SKAGWAY FERRY TERMINAL ELECTRICAL IMPROVEMENTS
PROJECT NO. 68161/ NH-097-1(5)

AS-BUILT DRAWINGS

SITE PLAN

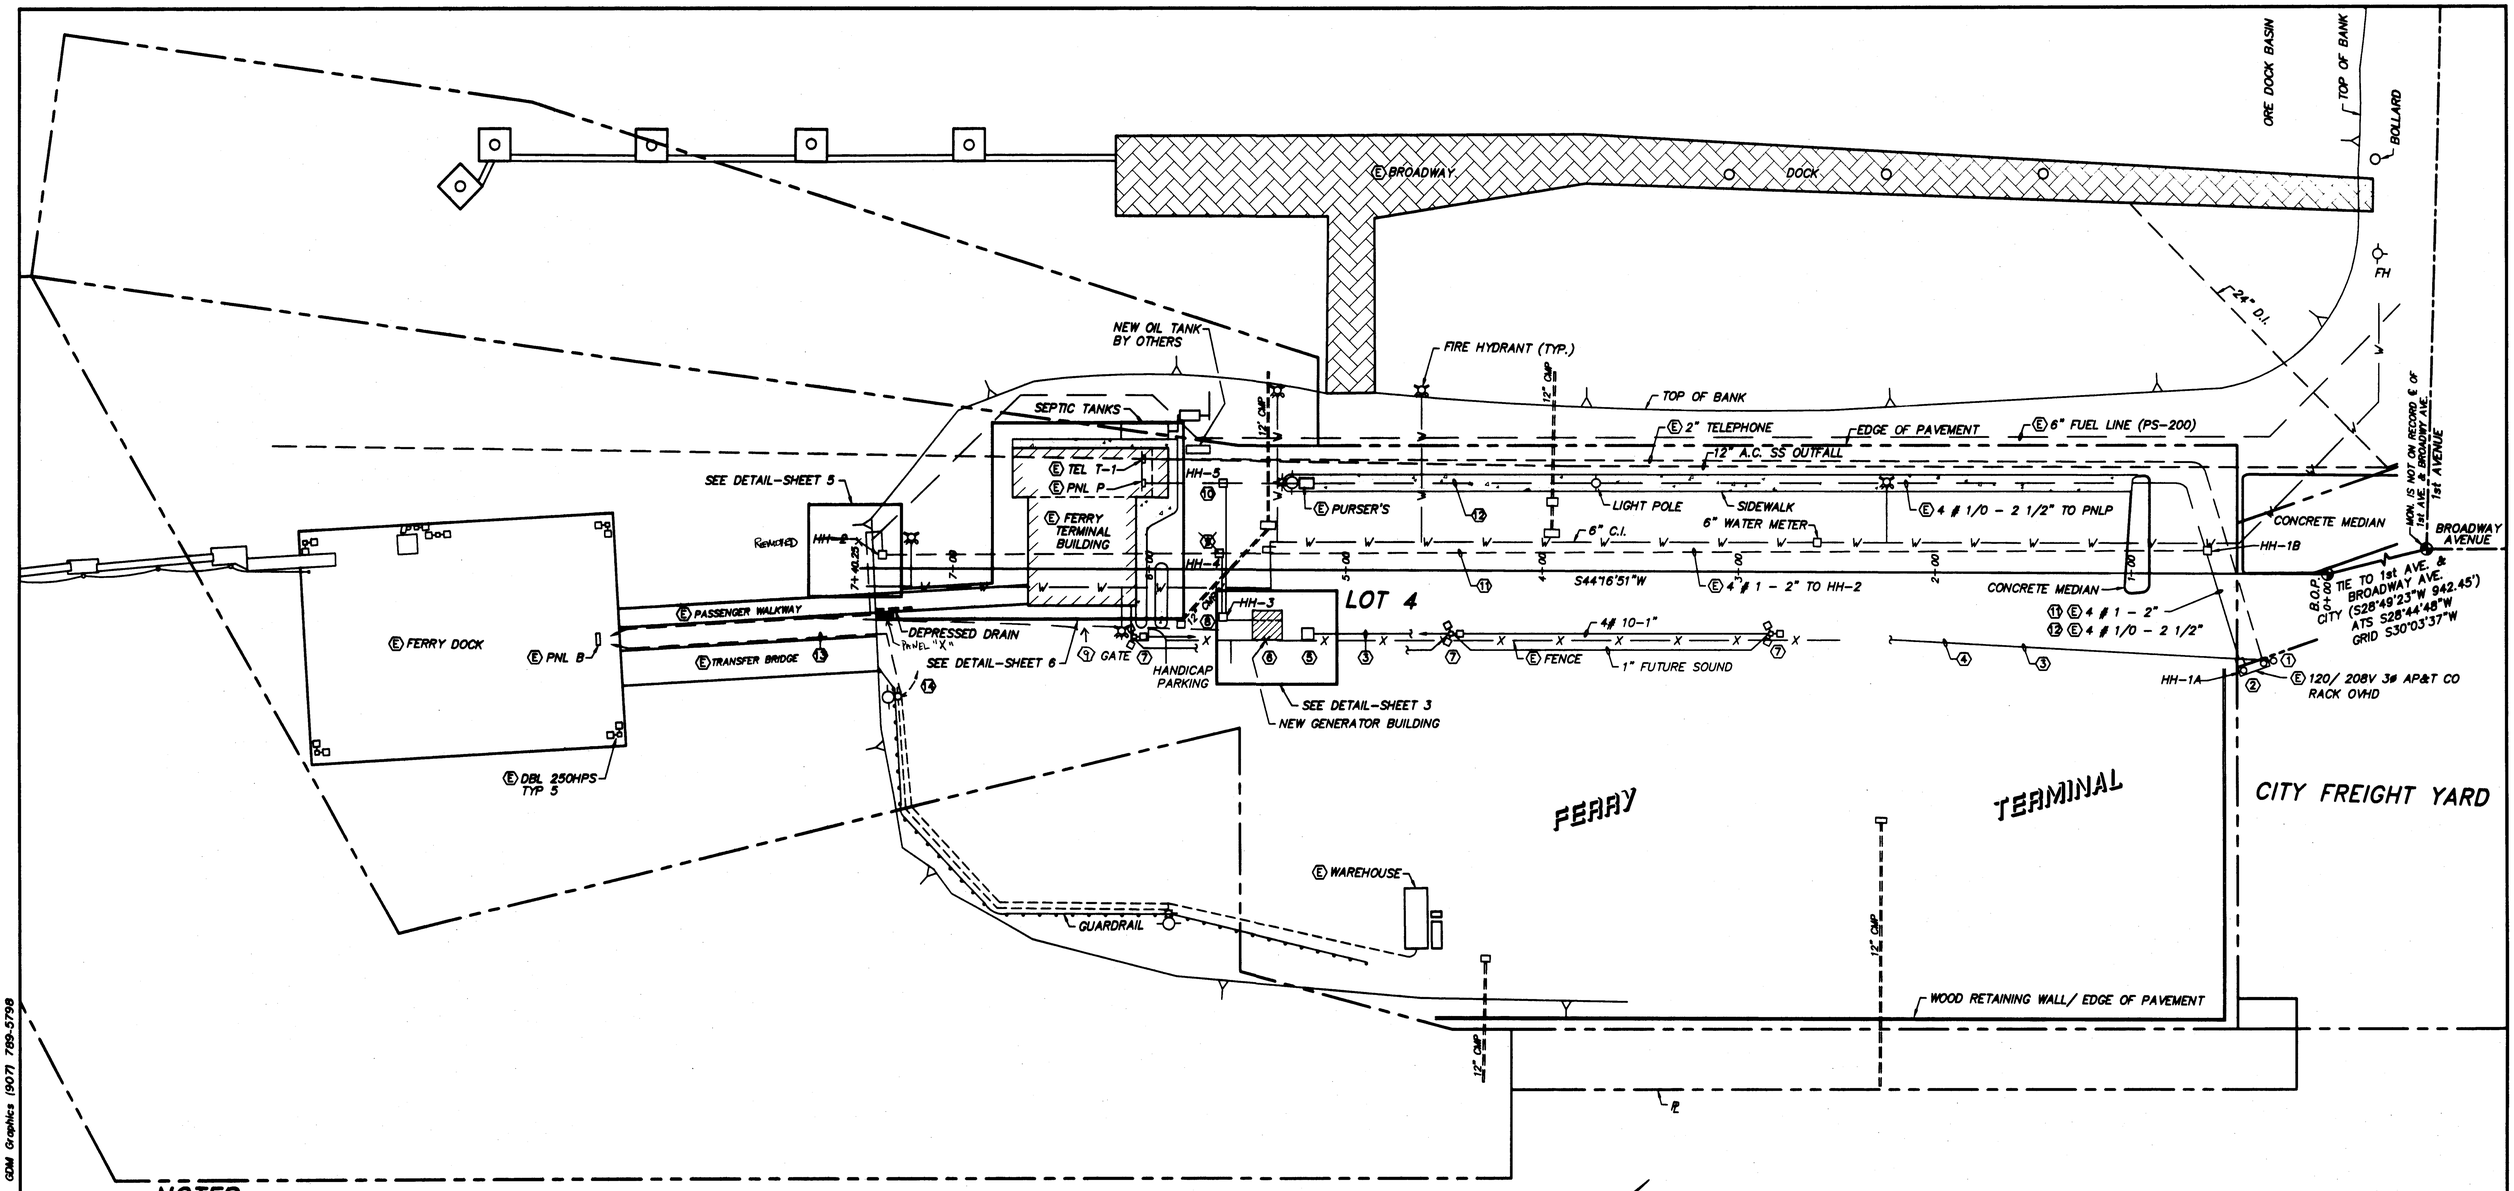
9. 4'-0" x 4'-0" x 4'-0" HAND HOLE #4. SEE DETAIL-SHEET 7. ~~INTERCEPT EXISTING 2" RGC.~~ REMOVE EXISTING 4#1 ~~AND REPLACE WITH~~ 4#1 XHHW-2 FROM MDP TO ~~HH-2.~~ BRIDGE ABUTMENT.

14. REROUTE EXISTING 2#8 - 1" RGC ~~FROM HH-2~~ TO PANEL "X".
15. FIELD VERIFY ALL STATIONS, OFFSETS AND STRUCTURE LOCATIONS WITH THE ENGINEER.
